Subject: AP1000 Response to Request for Additional Information

Westinghouse is submitting a response to the NRC request for additional information (RAI) on SRP Section TR54. This RAI response is submitted in support of the AP1000 Design Certification Amendment Application (Docket No. 52-006). The information included in this response is generic and is expected to apply to all COL applications referencing the AP1000 Design Certification and the AP1000 Design Certification Amendment Application.

RAI-TR54-015 R3
RAI-TR54-026 R2

AP1000 TECHNICAL REPORT REVIEW

Markup of DCD Rev. 17 Figure 9.1.4:

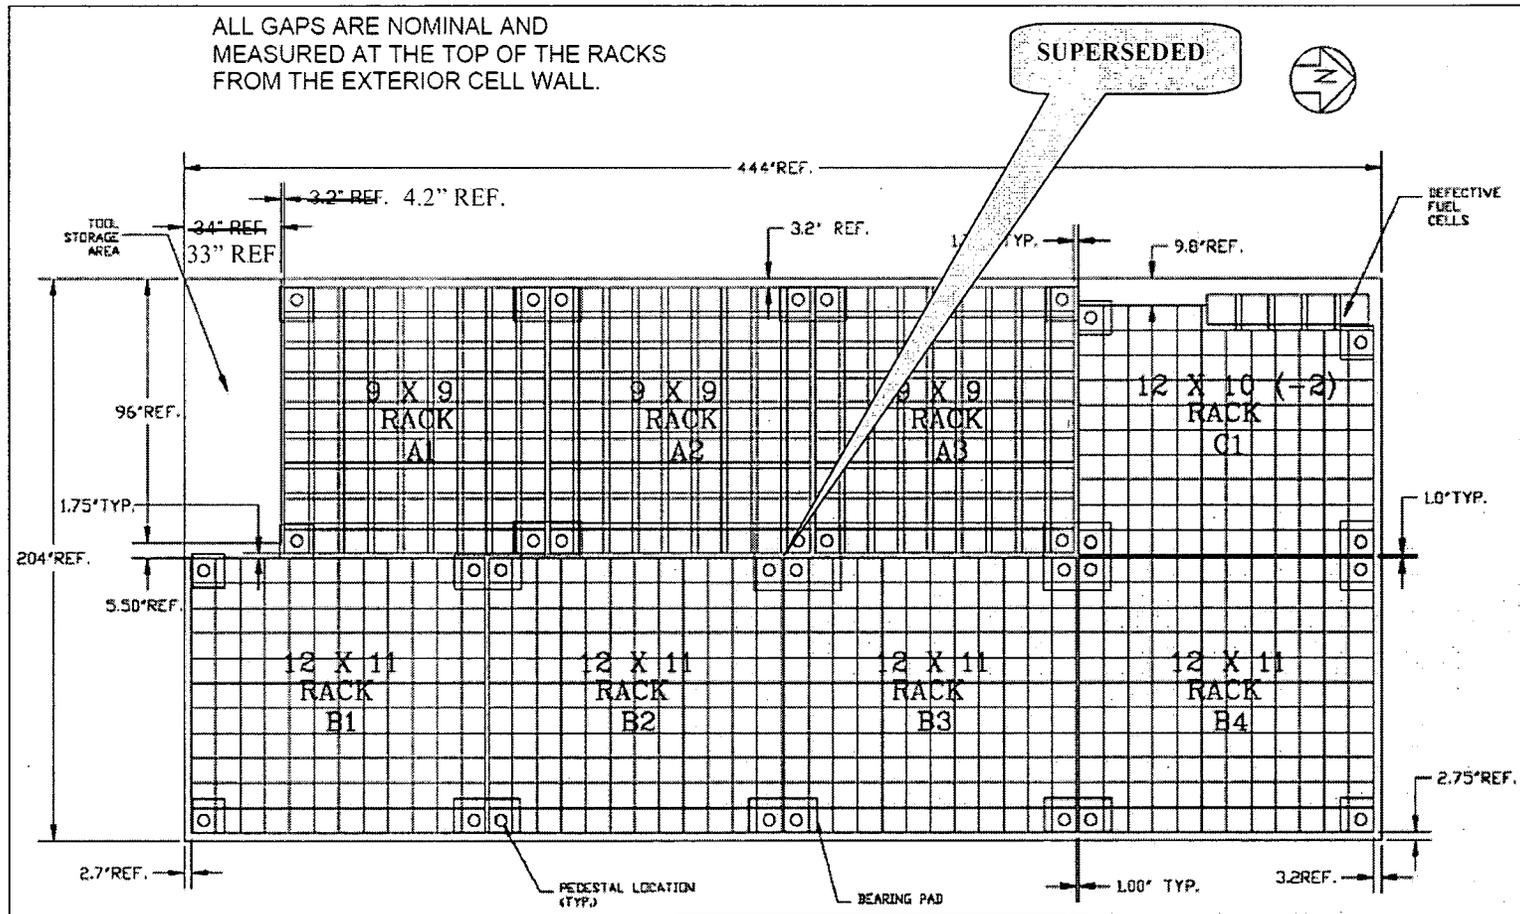
During the August 6-7, 2009 meeting with the NRC it was identified that spent fuel rack A1 is shown to slide into the area of the spent fuel pool designated as the "Tool Storage Area". To eliminate this from happening, the Tool Storage Area has been resized from 34 inches wide with a 3.2 inch gap from the tool storage area to rack A1, to 33 inches wide with a 4.2 inch gap. This increase in gap size precludes rack A1 from entering the tool storage area as the result of a seismic event.

~~DCD Changes: The markup of DCD Rev. 17 Figure 9.1.4 below shows the modification in the tool storage area size.~~

Markup of TR-54 Rev. 2 Figure 2-1

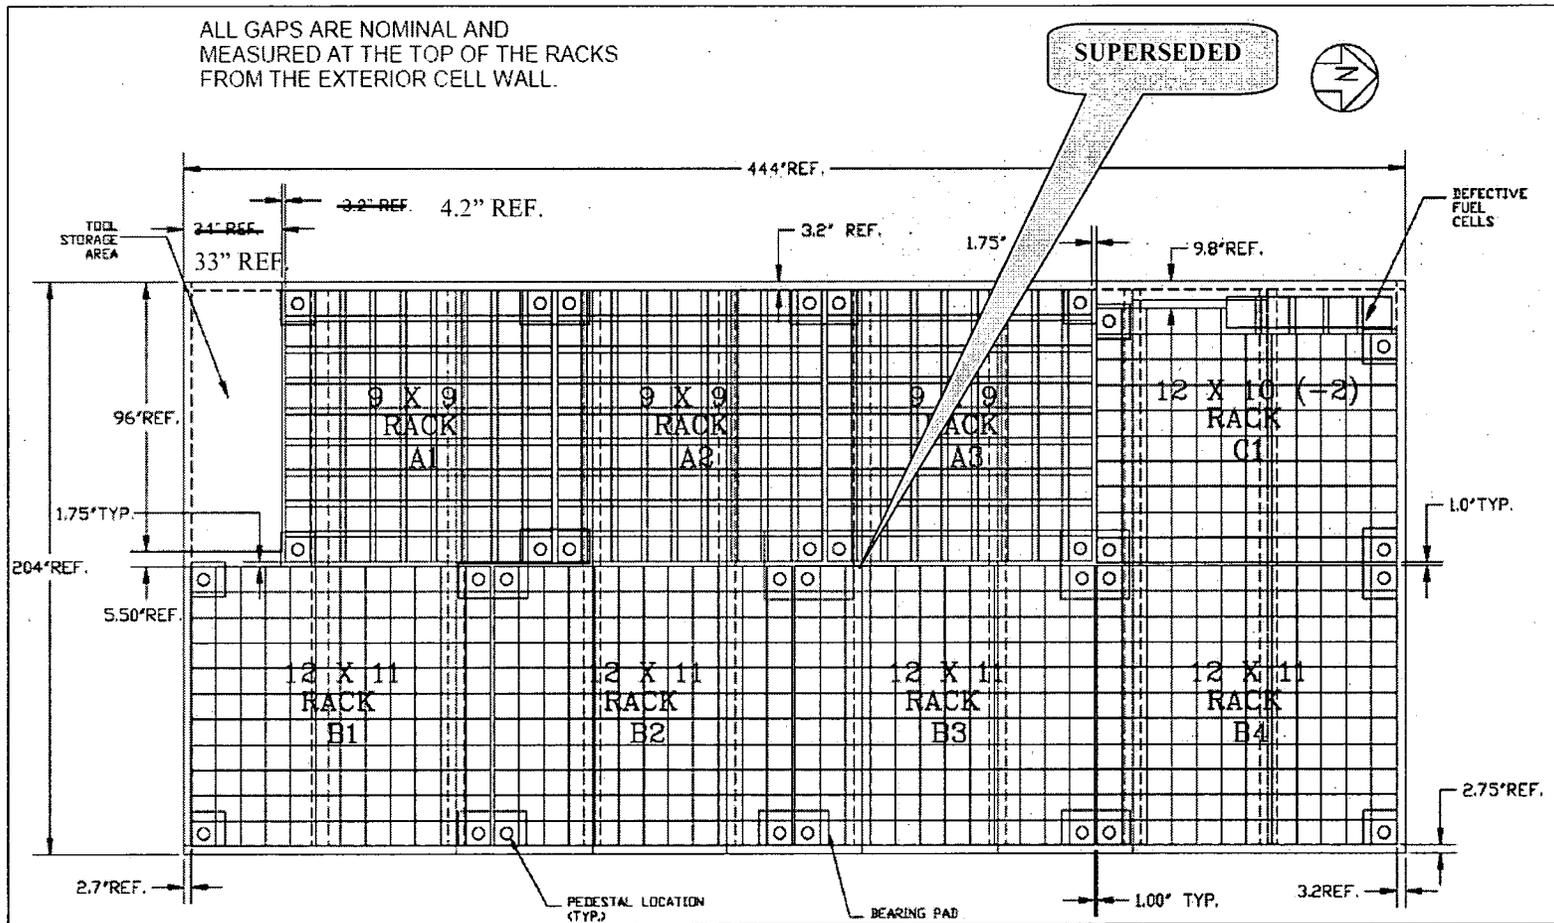
~~The markup of TR-54 Rev. 2 and Figure 2-1 below shows the modification in the tool storage area size.~~

Figure 9.1-3 (Sheet 1 of 2) Region 2 Spent-fuel Storage Rack Layout

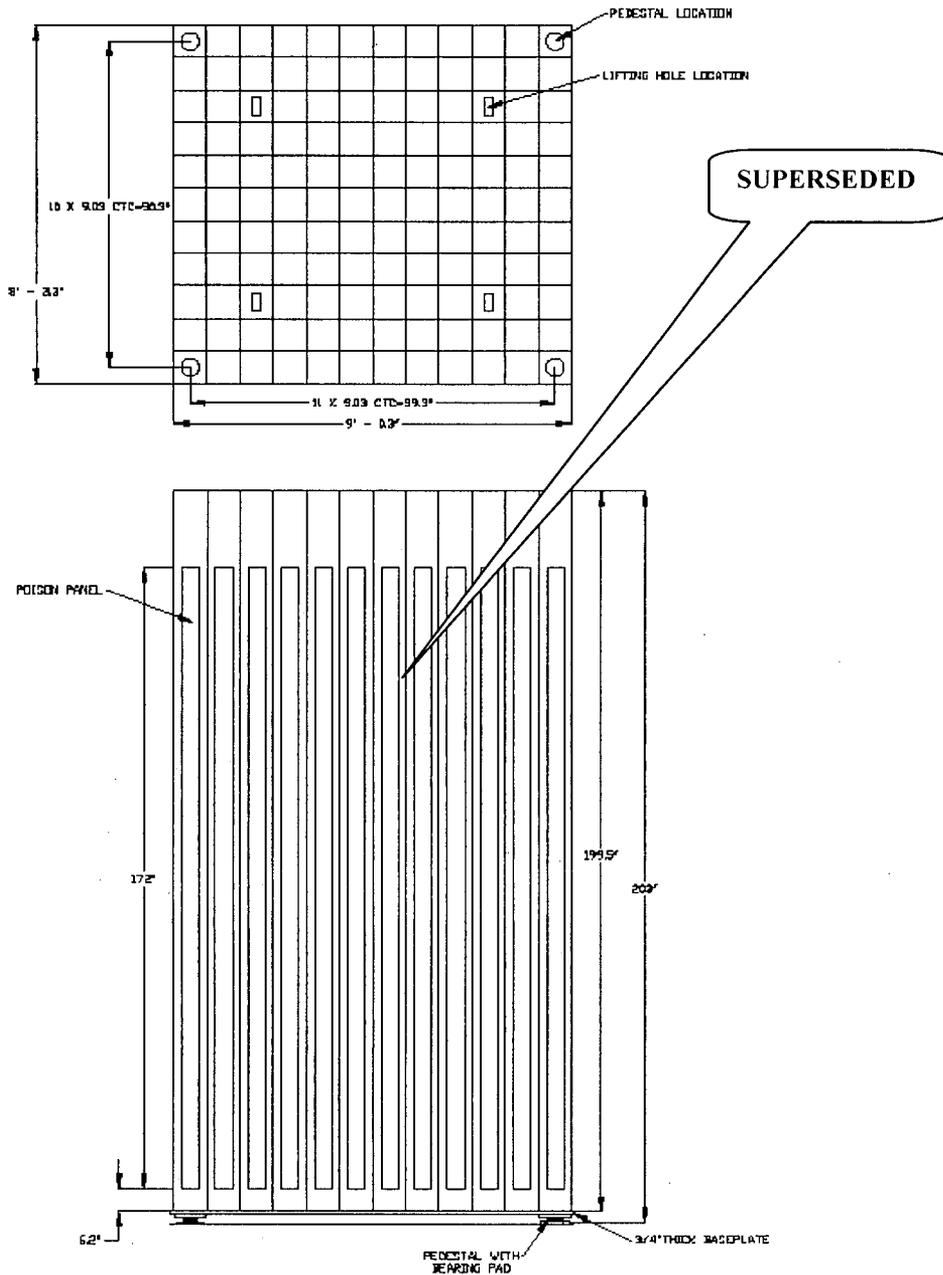
~~Westinghouse agreed to change spent fuel pool rack layout shown in Figure 2-1 of TR-54 Rev 2 and DCD Figure 9.1-4 to change note to "All gaps are nominal and measured at the top of the rack from the exterior cell wall". Also from RAI-TR54-36 Rev 2 response, the tool area is shown to be 34 inches rather than 36 inches. In addition, Figure 2-3 and DCD Figure 9.1-3 (sheet 1 of 2) have been changed to correctly reflect the distance from the TOP of the bearing pad (not the bottom of the bearing pad) to the top of the rack.~~

Replace Figures 9.1.3 (Sheet 1 of 2) and 9.1.4 with the following:

Figure 2-1 Spent Fuel Pool Storage Layout (889 Total Storage Locations)
 Note: leak chases shown in phantom

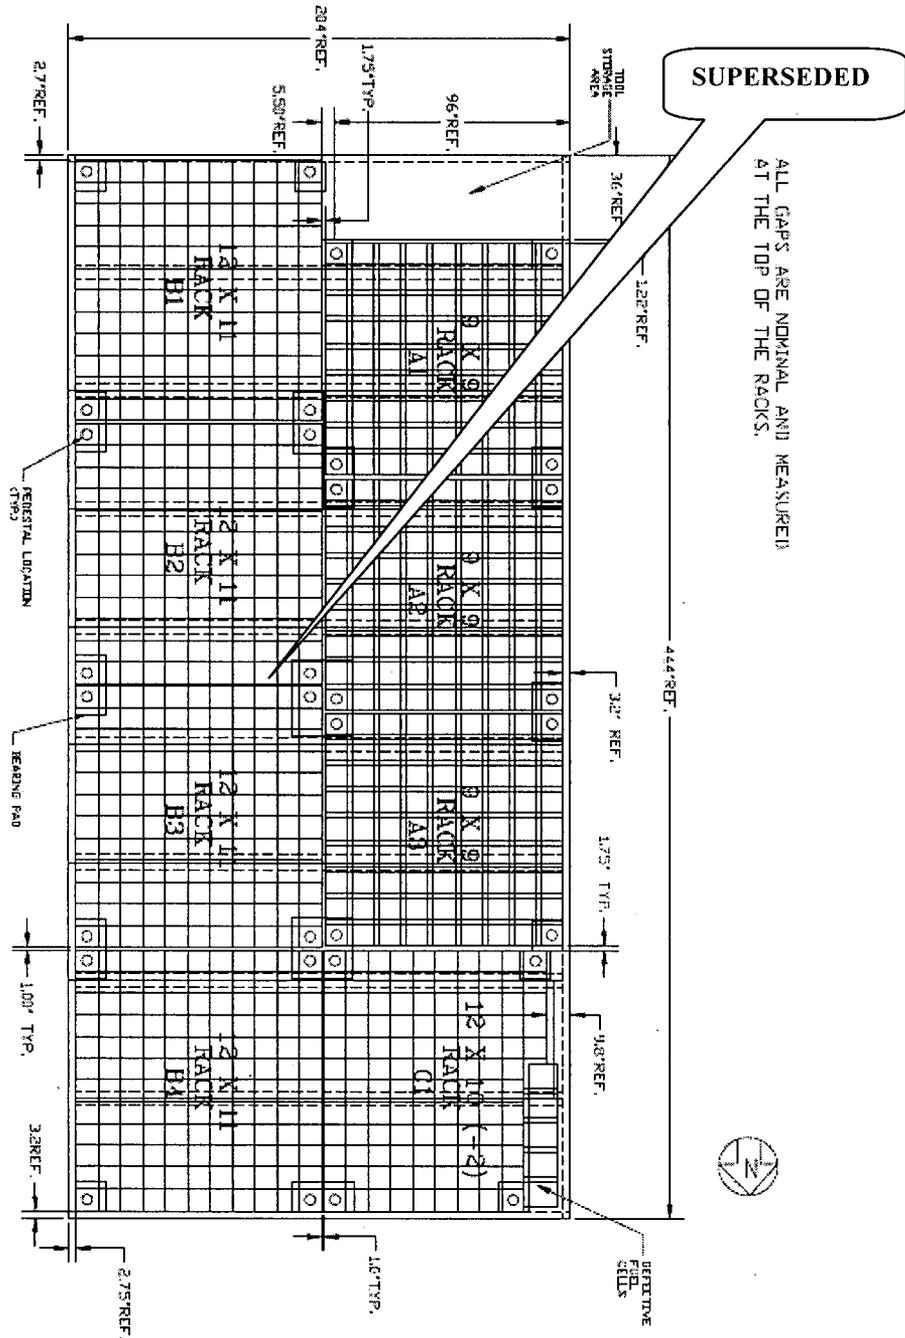
- (3) Figure TR54-15.6 (in the RAI response) does not show any leak chase channels in the spent fuel pool floor. W indicated that there are leak chase channels; however they are not shown in rack layout figure. W confirmed that the fuel rack analyses did not consider the possible impact loading of a rack pedestal over the leak chase channel. Therefore, the staff request W to explain why the effects of the leak chase channel were not considered in the fuel rack analyses and the calculation that demonstrates the adequacy of the liner/concrete in the local region around the pedestal which is part of the TR report. Also, Figure TR54-15.6 which will be included in the TR should be revised to show the leak chase channels if they are used.

~~Westinghouse has revised the layout figures for Region 1 and Region 2 spent fuel racks as requested. These figures are presented below in the DGD Revision and TR Revision sections below. Leak chases are used in the spent fuel pool. The plates making up the spent fuel pool liner have been designed such that no rack pedestals are over leak chases.~~

Figure 2-2 Configuration of a Region 1 Storage Cell (Sheet 1 of 2)

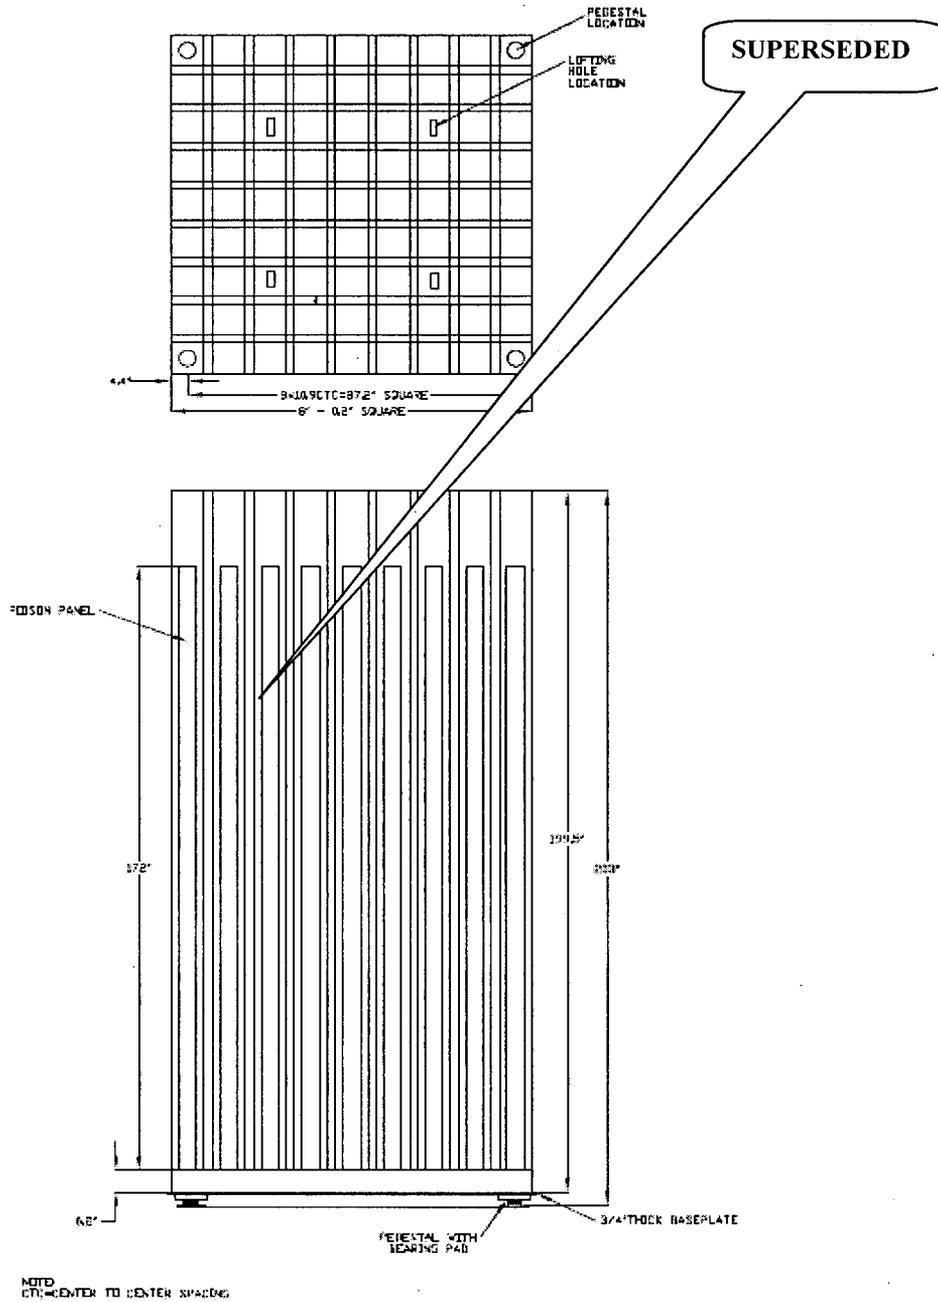
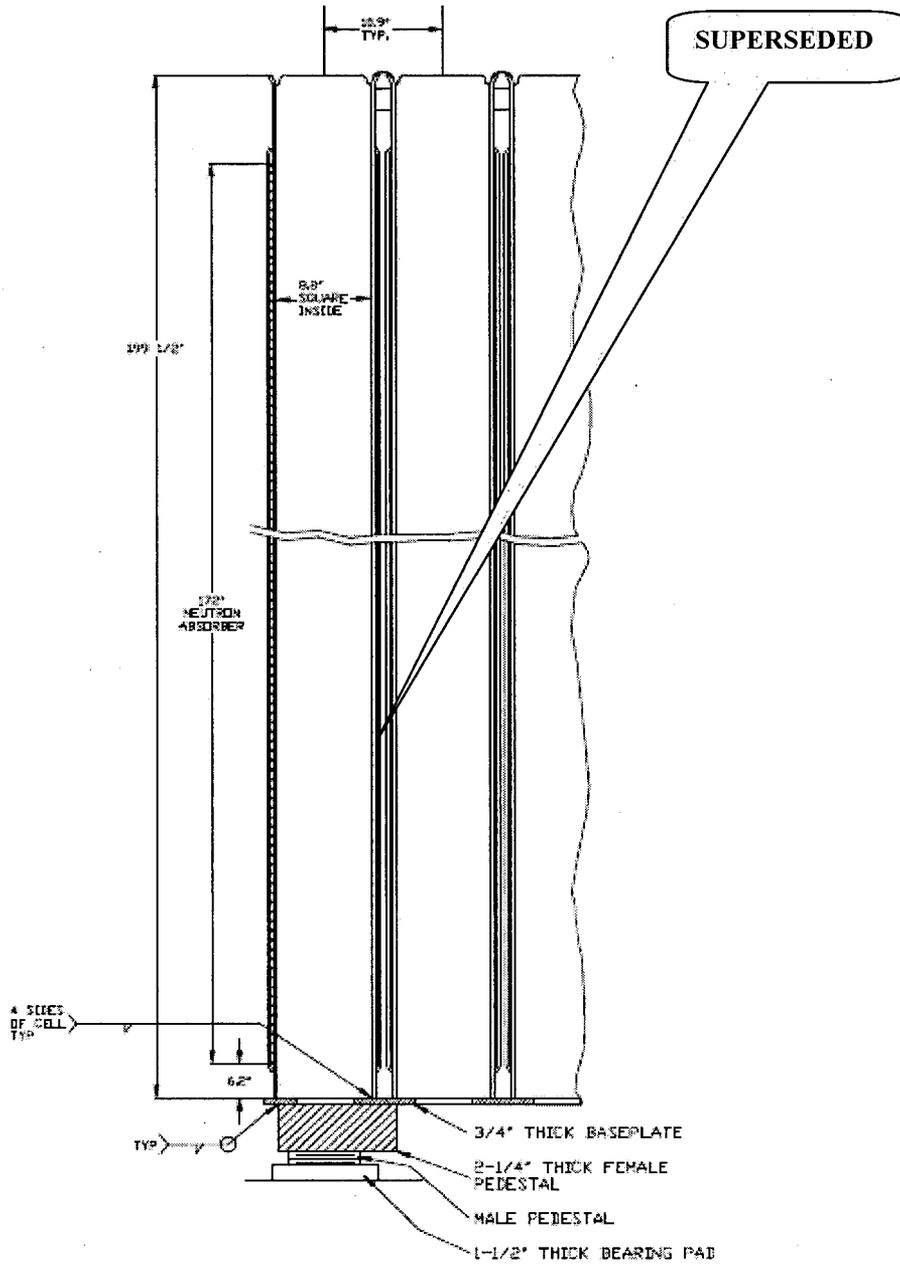
- (1) The key dimensions of the male and female pedestal components and bearing plates should be shown in the figures provided in the RAI response.
- (2) The welds connecting the pedestals to the baseplate and the baseplate to the fuel cell walls are not shown. The information for the welds should indicate the type of the weld (e.g., fillet) and whether they are all around or the extent of the welds.
